CITY OF ALBUQUERQUE

**RE: Safety Counseling Office
2900 Wellesley NE
30-day Temporary C.O. - Accepted
Engineer's Certification Date: 02/22/24
Engineer's Stamp Date: 04/12/23
Hydrology File: H16D101**

DRAINAGE CERTIFICATION FOR TEMPORARY CERTIFICATE OF OCCUPANCY

GRADING AND DRAINAGE PLAN

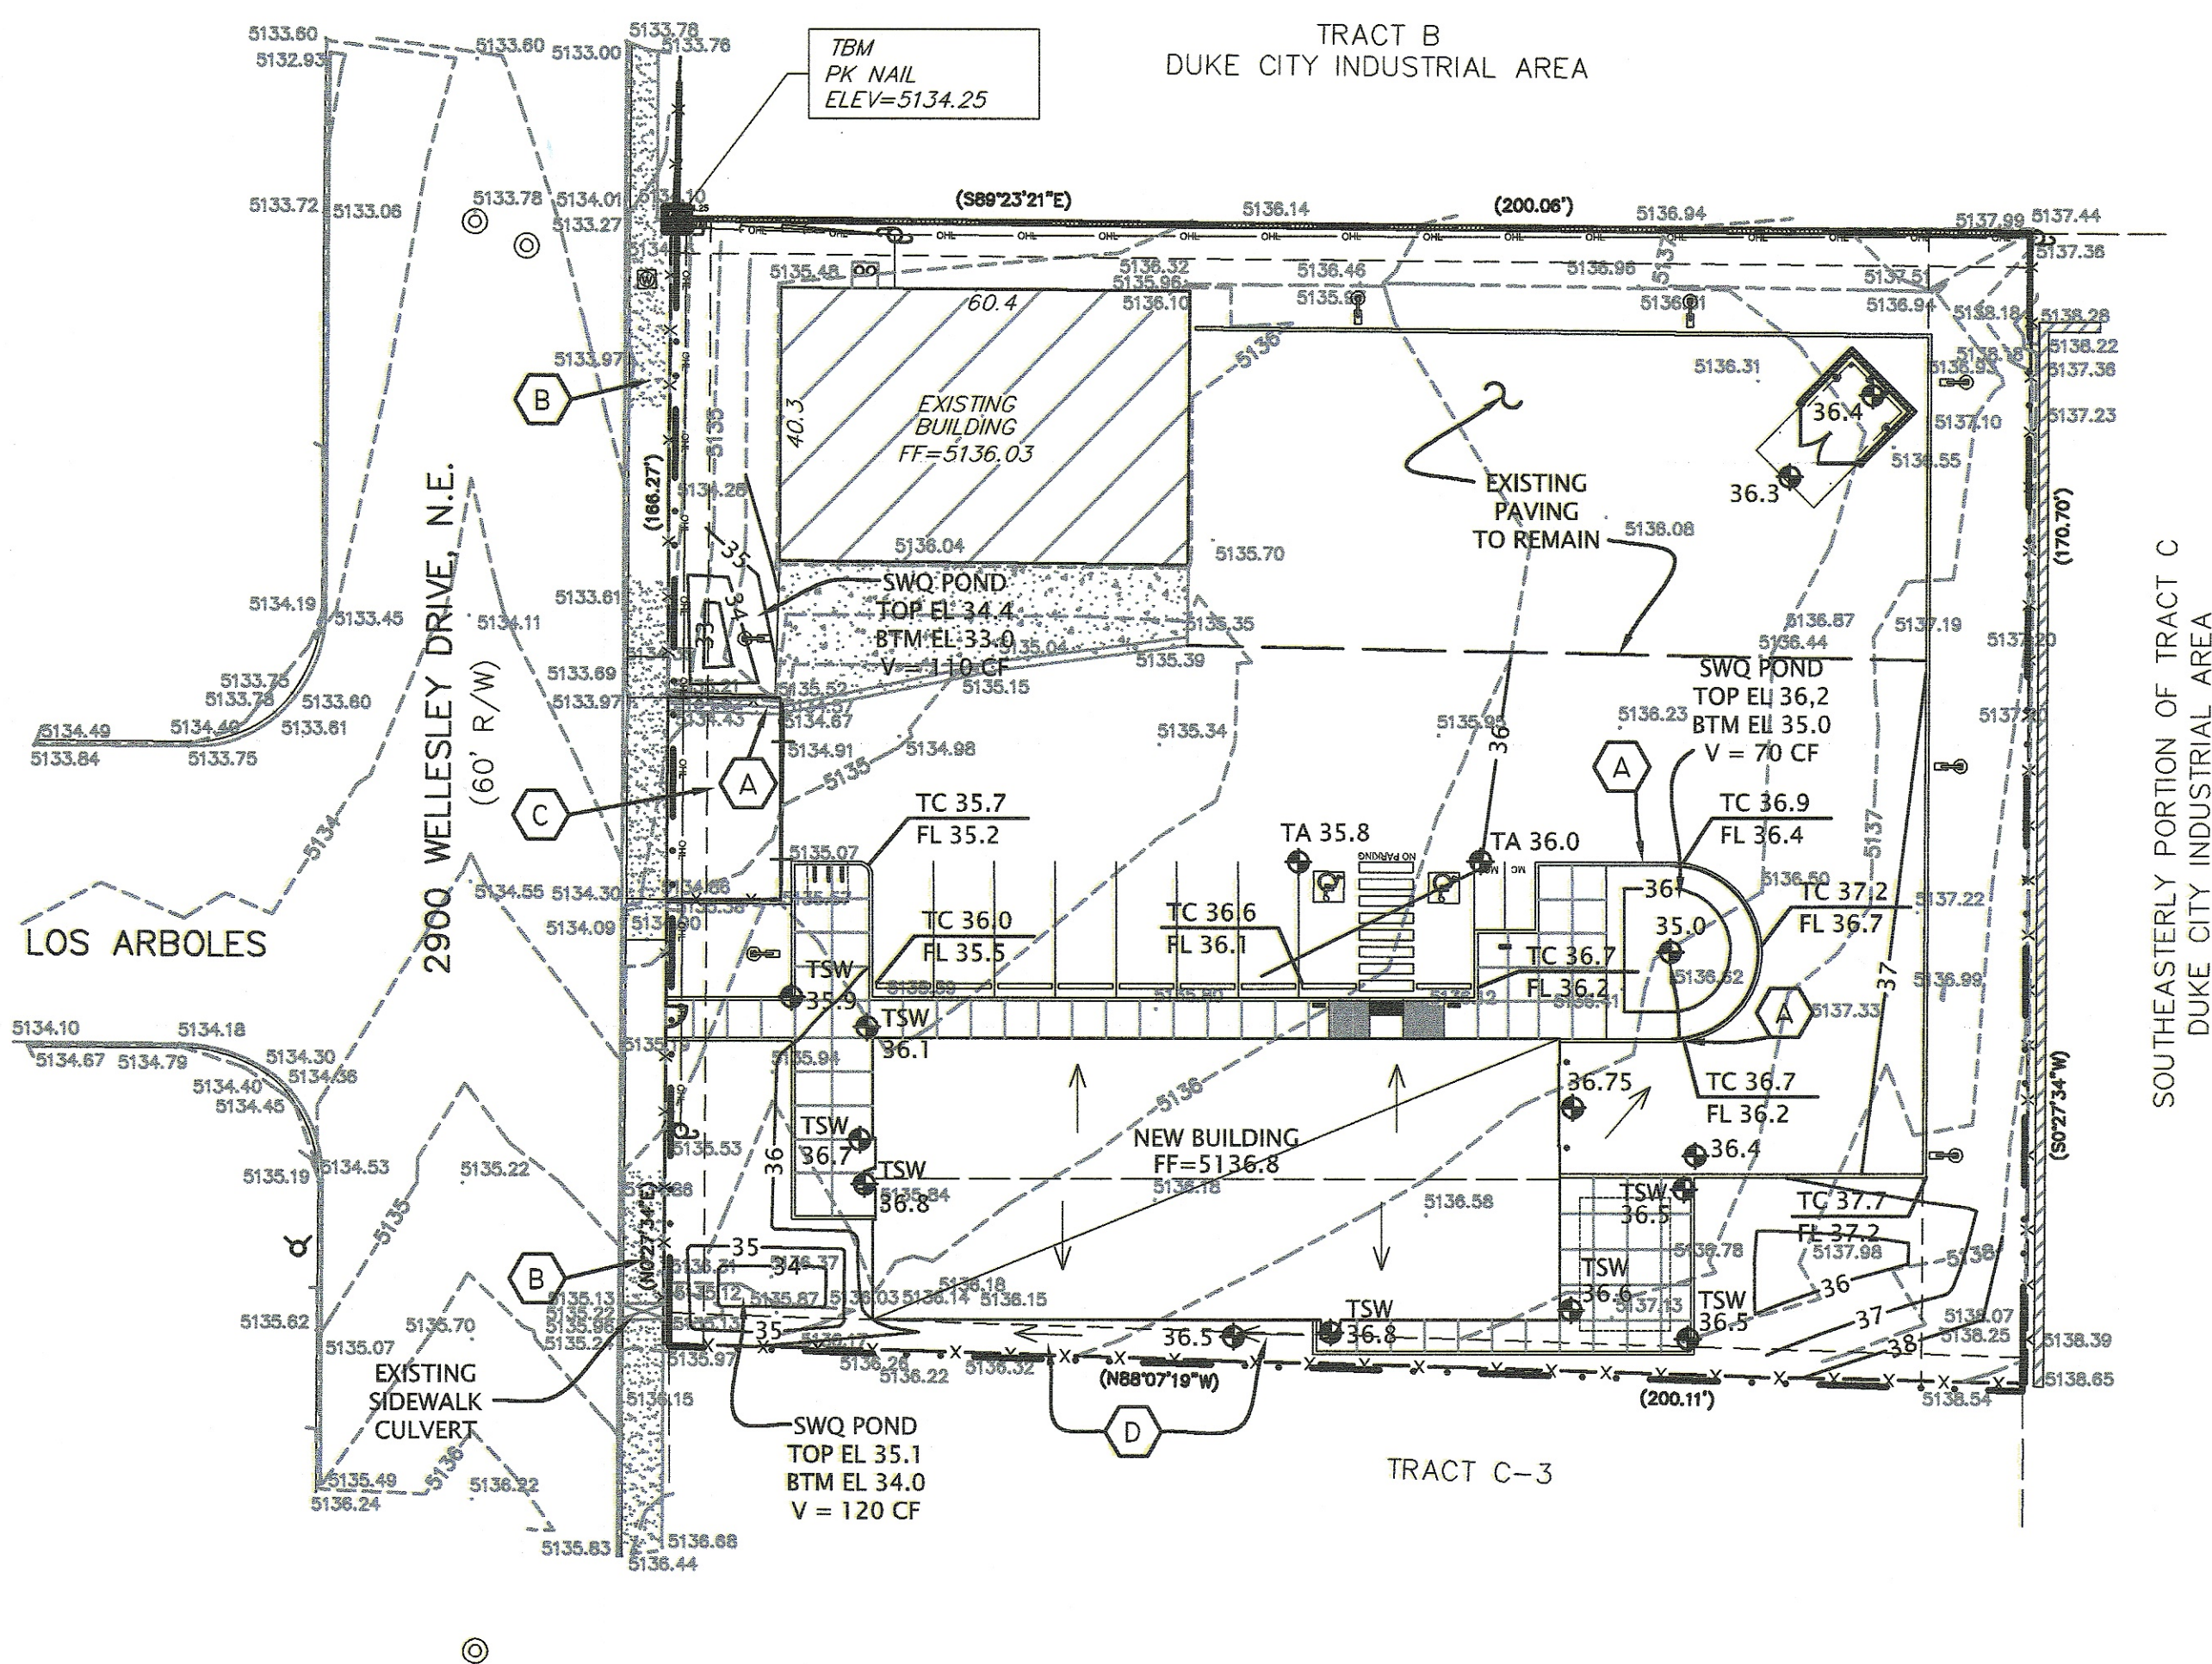
1. Please Resubmit to PLNDRS@cabq.gov when ready with an updated City of Albuquerque engineer's certification on the as-built Grading & Drainage Plan.
2. Please provide the executed paper Drainage Covenant (latest revision) printed on one-side only with Exhibit A and a check for **\$25.00** made out to “**Bernalillo County**” for the stormwater quality ponds per Article 6-15(C) of the DPM to Hydrology for review at Plaza de Sol.
